Project	Kingsway Business Park		
Document Number	KBP-BWB-ZZ-XX-RP-CD-0004	BWB Ref	NTW2889
Author	David Gray	Status	S2
Checked	Matthew Bailey	Revision	P1
Approved	Rowan Jobling	Date	15.07.2022

Summary of Surface Water Sewer Modelling

Figure 1.1: Business Park overall indicative catchments and attenuation ponds.

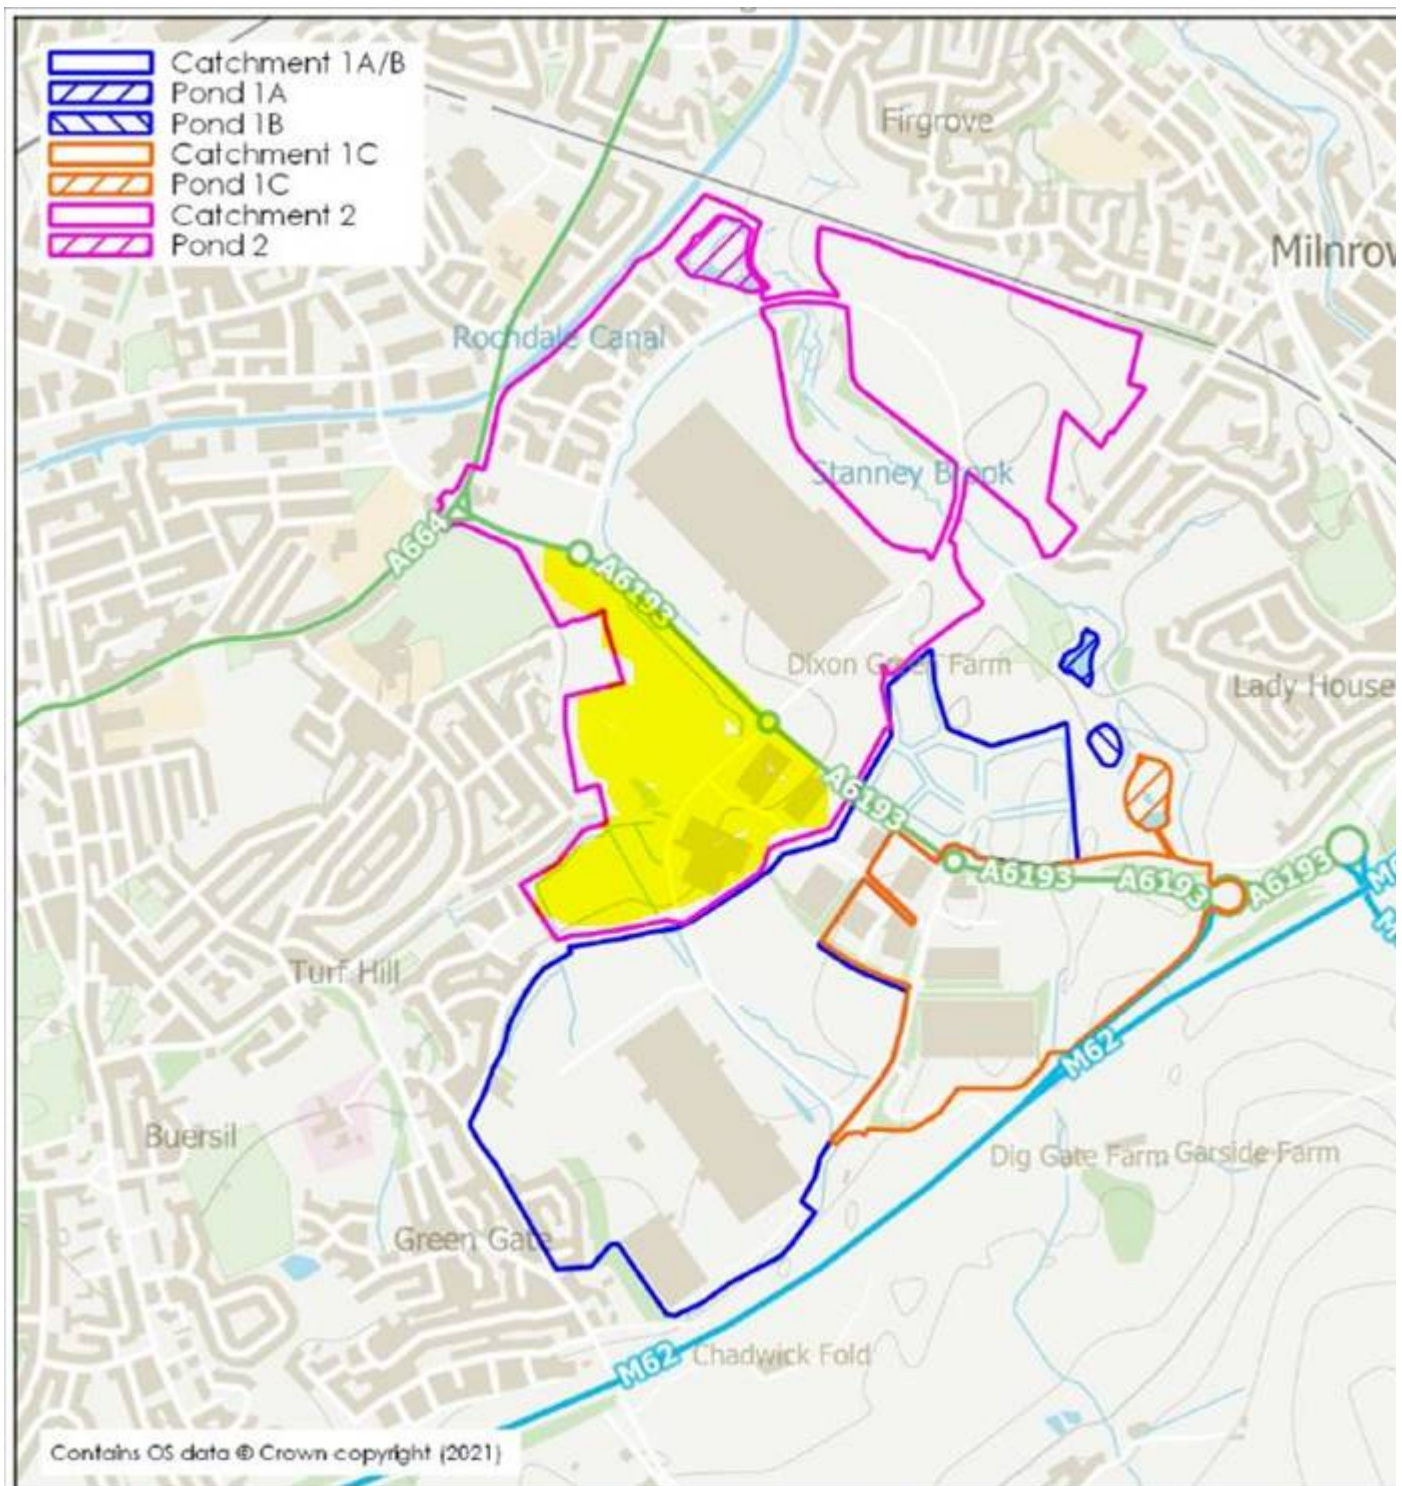
Thanks for your email, I had this morning a conversation with my colleague Robert, I understand that previously both of you deals with Catchment 1A/B (blue in the below picture).

Currently, we are dealing with catchment 2 (pink colour), the developer contact our team regarding plot M (highlighted in yellow).

The provided modelling of catchment 2 has been done in line with previous model of catchment 1A. Previously 1A showed issues at the pond but the sewer network was fine.

Where catchment 2 model shows the pond is fine but the sewer network has a small amount of flooding (13m³) within Sir Isaac Newton Way.

Also, the developer stated in the document no: KBP-BWB-ZZ-XX-RP-CD-0003, that the 'Pond 2' discharges surface water at a lower rate (444.5l/s) that of the original design intent (555l/s).

Could the developer provide the mdx. file to Stephen to run the model as you did for catchment 1A as a sense check.

Finally, whilst we have no problems with the proposal in principle...as there is a small amount of flooding on the sewer network, we request that this is investigated as there may be some remedial work to be done at the pond again as it does not appear to be passing forward the flow to the watercourse as it was originally designed to.

Mohammed, the flooding occurs in the sewers located quite some way from Pond 2 and is not affected by the water level within Pond 2 or the flow rate from Pond 2.

As shown in the extract below, the flooding occurs at MH S317 in the short duration (30 min) / high intensity rainfall event and is due to the flow rate exceeding the capacity of the pipe for a short duration. Based on

the volume shown in the hydraulic model, any flooding would be entirely contained within Sir Isaac Newton Water and drain back down into the system once the peak storm has passed. This is standard practice for designing drainage systems.

In reality, surface water drainage features (gullies, slot drains, kerb drains) are not designed generally designed a much lower storm event, typically the 5 year storm. So although the model shows flooding in the 100 year storm, the water would not have drained into the sewers in the first instance. The surface water would pond on the road surface as the capacities of the road gullies would have been exceeded before the capacity of the sewers.
